Re: Landfill 2/3 Post-Closure Operations and
Maintenance Manual Addendum
Landfill 2/3, 5, and 7 Cover Improvements
Former Griffiss AFB, Rome, New York

**TECHNICAL REVIEW
LANDFILL 2/3 POST CLOSURE
OPERATIONS AND MAINTENANCE MANUAL
Former Griffiss Air Force Base
Rome, New York**

***LANDFILL 2/3
POST-CLOSURE OPERATIONS &
MAINTENANCE MANUAL ADDENDUM***

LANDFILL COVER AS-BUILT
DRAWING
NEW PASSIVE GAS VENT

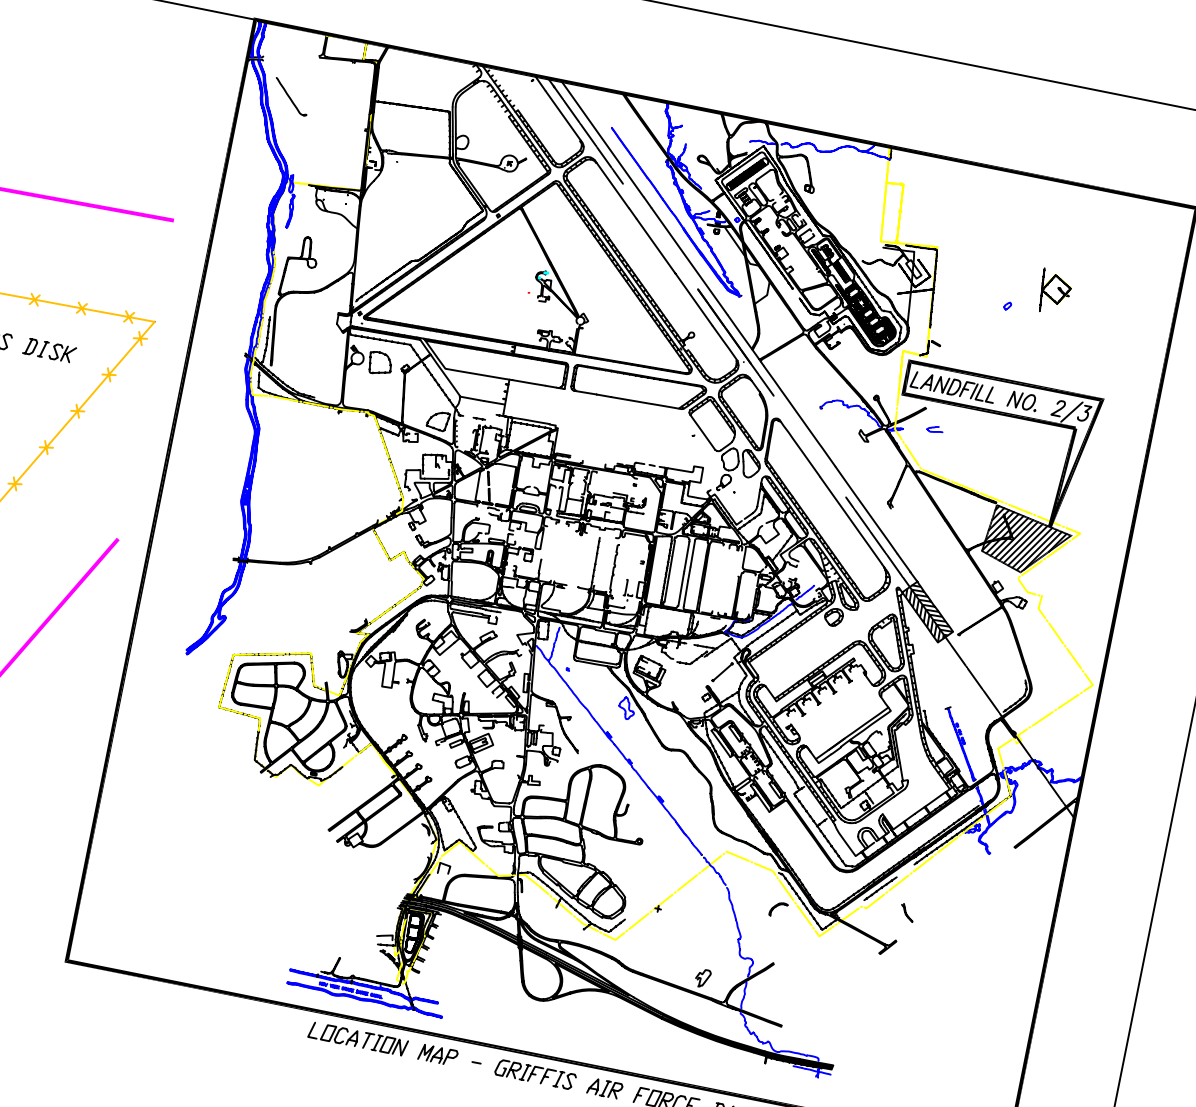
17. **Appendix C.** Sheet C-3 provides a detail for the new passive gas vent. The detail references a 40 mil LLDPE (geomembrane) and two geocomposites: one above the geomembrane and one below the geomembrane. No geomembrane, and only one geocomposite is used in the remainder of the cover construction. Resolve the discrepancy.

Response: Comment noted. A revised drawing will be provided showing a detail for installation of a new passive gas vent, reflecting the final as-built condition of the existing gas vents.

FIELD SURVEY COMPLETED ON JUNE 28, 2004 (LAST REVISED 11/21/2005)
 TOPOGRAPHIC SURVEY MAP OF LANDFILL NO. 2/3
 FINAL GRADE PLAN
 FORMER G.A.F.B. CITY OF ROME
 ONEIDA COUNTY NEW YORK
 LAFAYE, WHITE & MCGIVERN, L.S., P.C.
 LAND SURVEYORS PHOTOGRAMMETRISTS
 THERESA BOONVILLE ROME
 NEW YORK

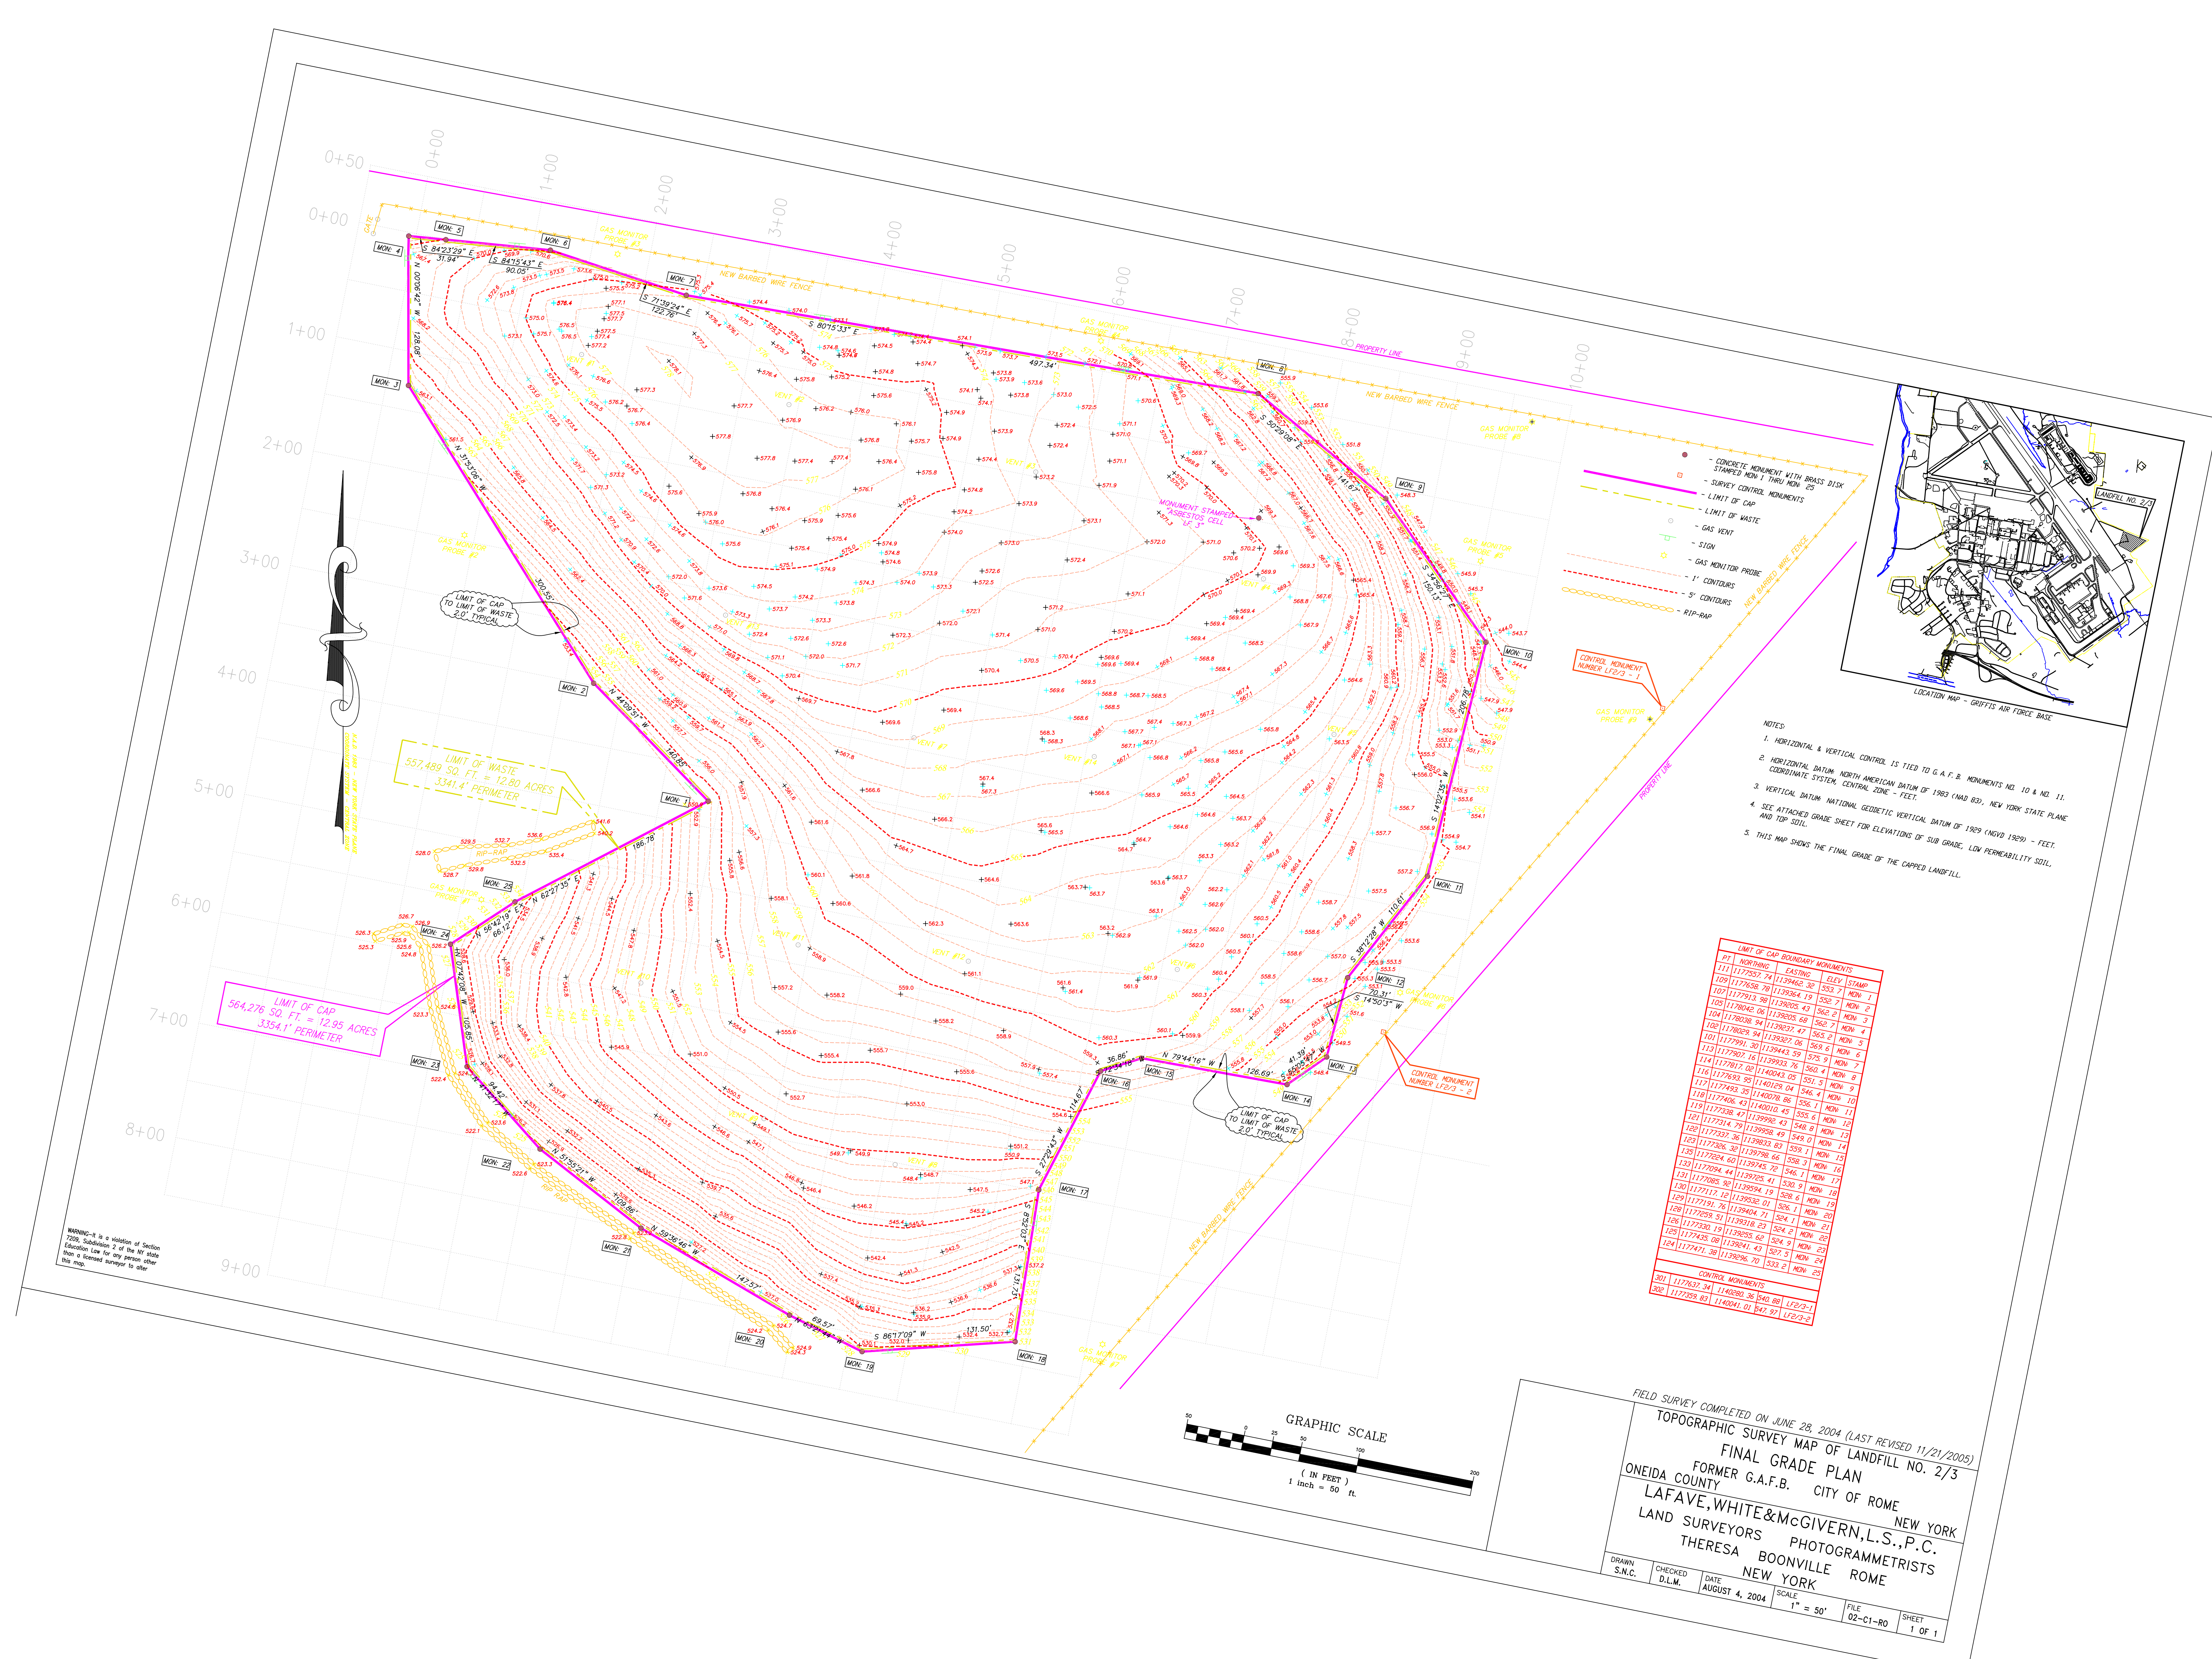
5. **Section 4.2 Inspection Items, Gas Venting Structures, Page 7.** The text states that there are 9 gas-monitoring probes. However, The Final Grade Plan prepared by LaFave White & McGivern in Appendix C, shows that there are 7 gas-monitoring probes. Resolve the conflict. A sampling location plan showing the actual number of vents and their as-built location along with the Buildings N0797 and 0762 would be useful. This plan, along with a Table providing the designation, location (Northing and Easting) and a space for monitoring results should be included in Appendix A.

Response: The Long Term Monitoring Work Plan is being revised to incorporate the final monitoring points. A gas monitoring form has been added to Appendix A. The as-built survey map is also being updated to reflect all existing monitoring points. Facility N0797, a concrete slab, and Facility 0762, a small 6' X 8' wooden storage building that is in disrepair and not being used, are located far to the south of the landfill and therefore, not shown on the landfill as-built figures.
